MWO 9-2320-386-20-1

## AIR PRESSURE RELIEF VALVE KIT MODIFICATION WORK ORDER

### MODIFICATION OF 2 1/2-TON ESP 6X6, M44A3 SERIES TRUCKS (DIESEL)

HEADQUARTERS, DEPARTMENT OF THE ARMY, WASHINGTON, D.C.  
17 June 2004

Figure 1

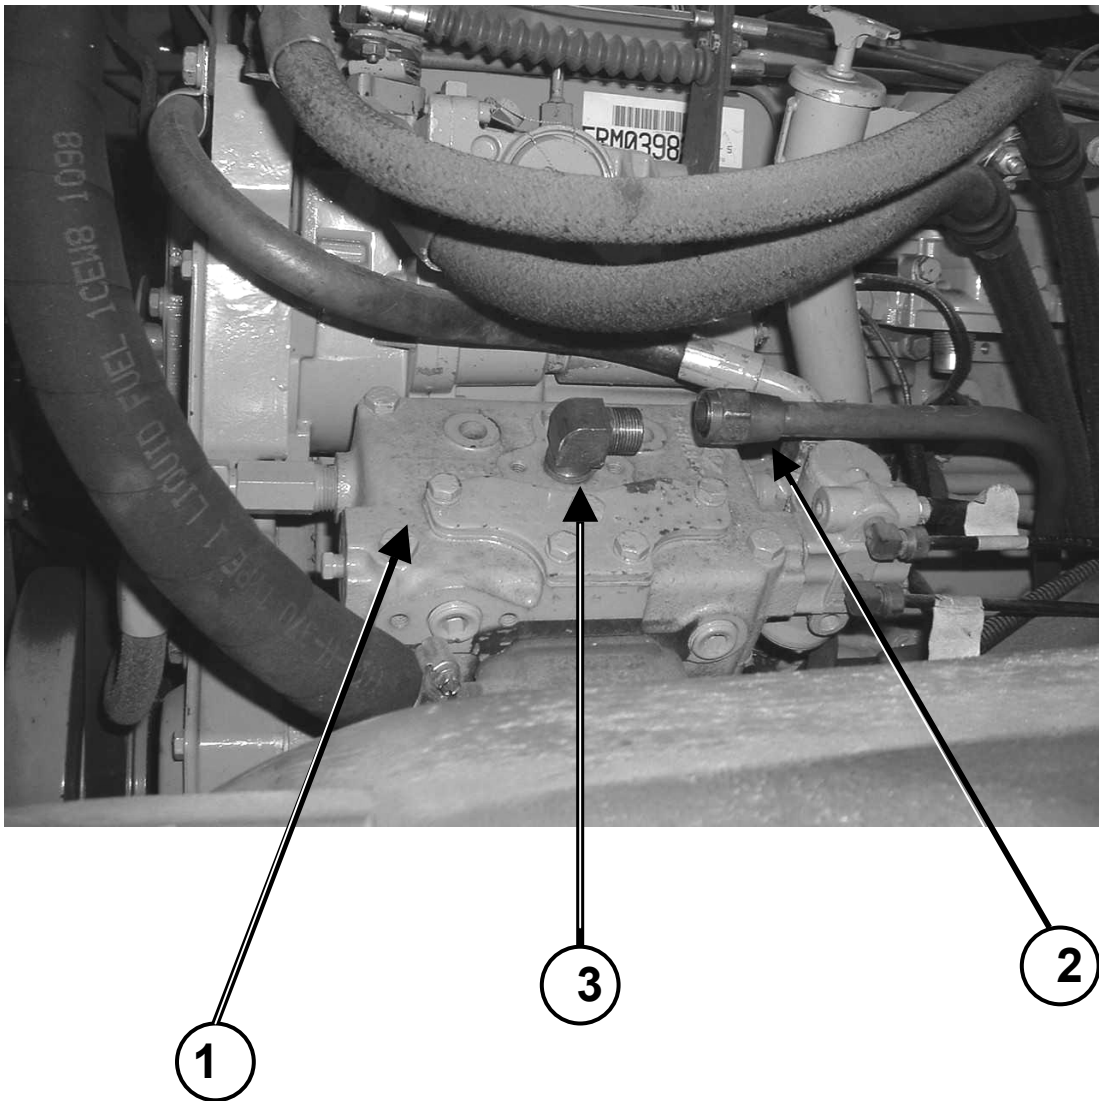
#### **Removal** (see figure 1)

- (1) Remove main air line (2) from air compressor outlet elbow (3).
- (2) Remove air compressor outlet elbow (10-8 120202BA) (3) from air compressor (1) and set aside for disposition per paragraph 8.

Figure 2

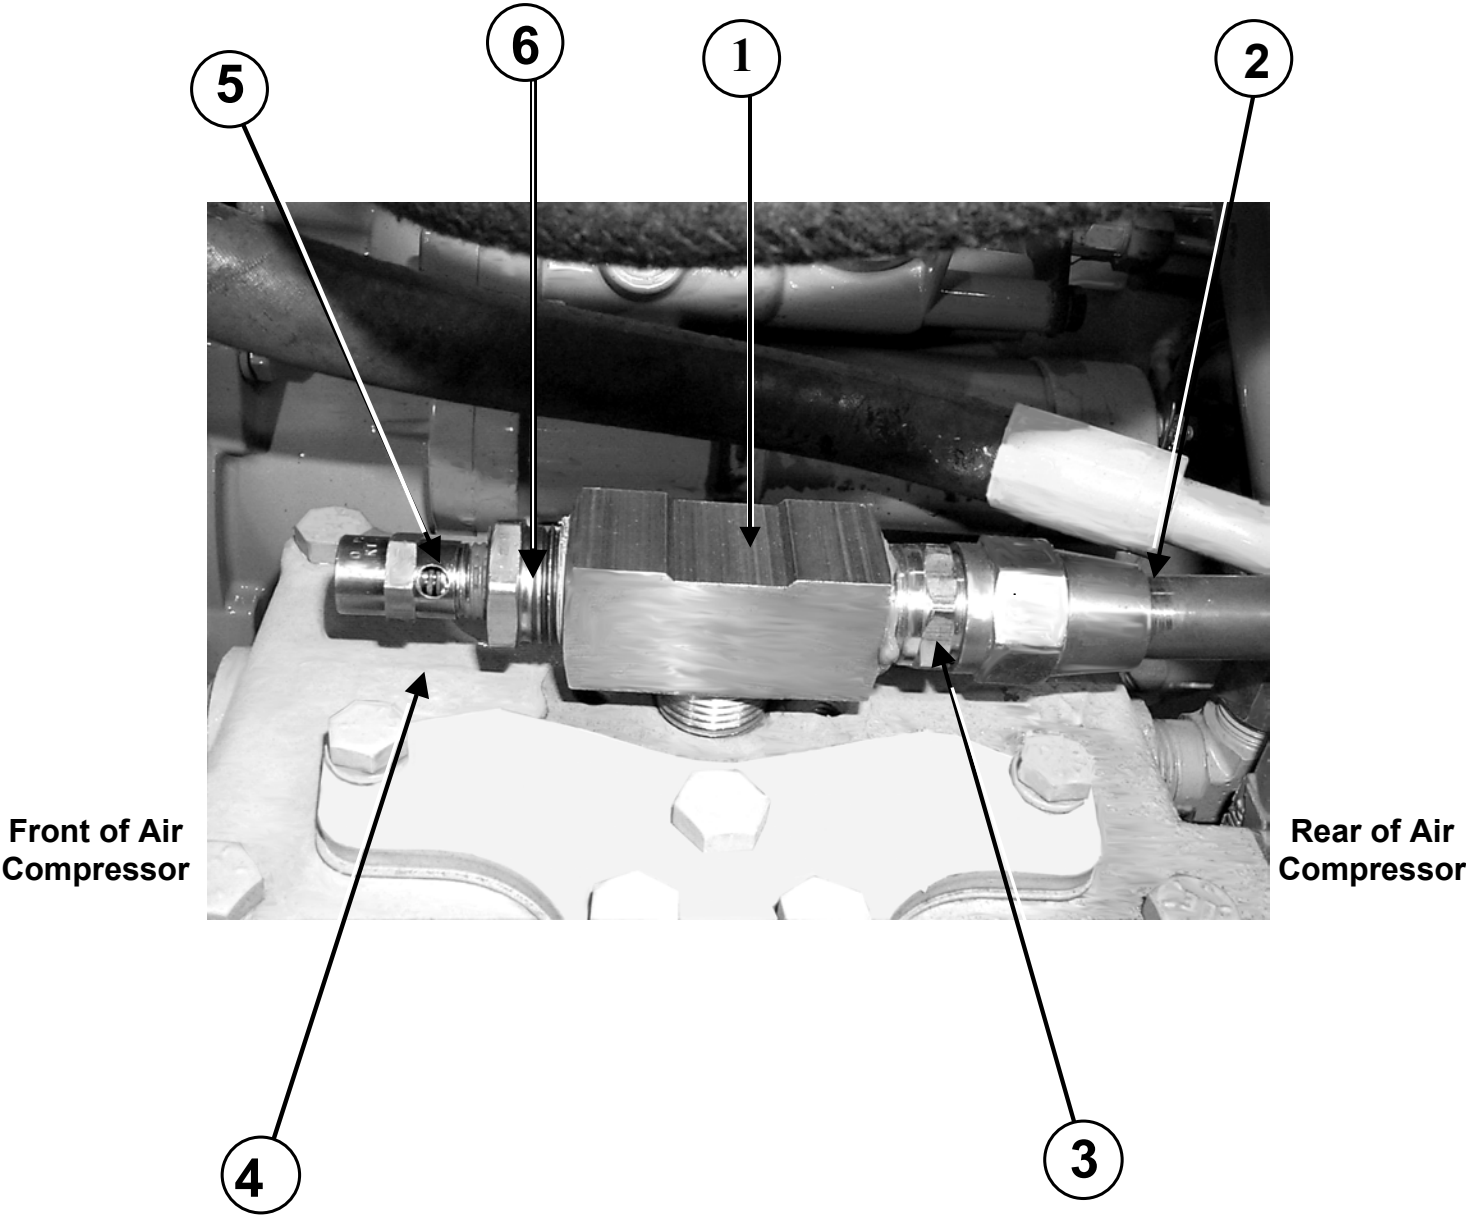
#### **Installation** (see figure 2)

- (3) Install tee (44Q236D35) (1) in air compressor (4) with outlet holes facing toward the front and rear of the vehicle.

- (4) Apply teflon pipe sealant to the male threads of adapter (68CA-10-8).
- (5) Install adapter (68CA-10-8) (3) in rear outlet hole of tee (44Q236D35).

- (6) Install main air line (2 ) on adapter (68CA-10-8) (3).
- (7) Install relief valve reducer (8-4 130140B) (6) in front outlet hole of tee (44Q236D35).
- (8) Apply teflon pipe sealant to the male threads of relief valve reducer (8-4 130140B).
- (9) Install air pressure relief valve (WHMBN1178DF) (5) in relief valve reducer (8-4 130140B) (6).

Figure 3

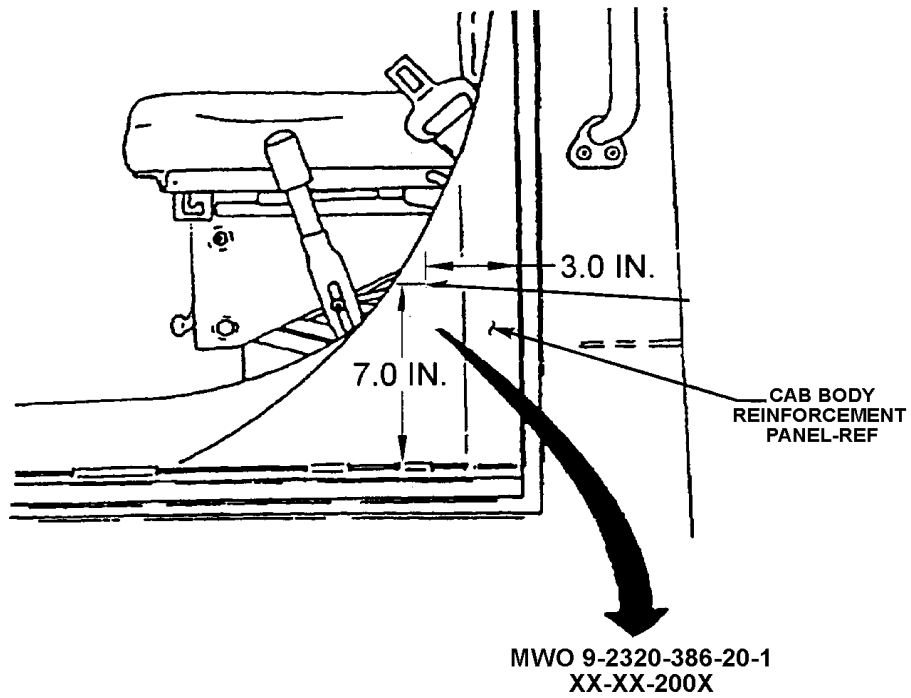
- b. **Marking Equipment.** After Air Pressure Relief Valve Kit is installed, stamp "MWO 9-2320-386-20-1" and the date installed on the Cab Body Reinforcement Panel using metal stamping die set (5110-00-293-1905) (see figure3).

- a. When stamped correctly, the MWO number and date will appear on the Cab Body Reinforcement Panel as shown in figure (3).
- b. After the Air Pressure Relief Valve Kit is installed, the vehicle air system should be tested for proper operation. Any faults detected or discrepancies noted will be corrected before the vehicle is returned to normal service.
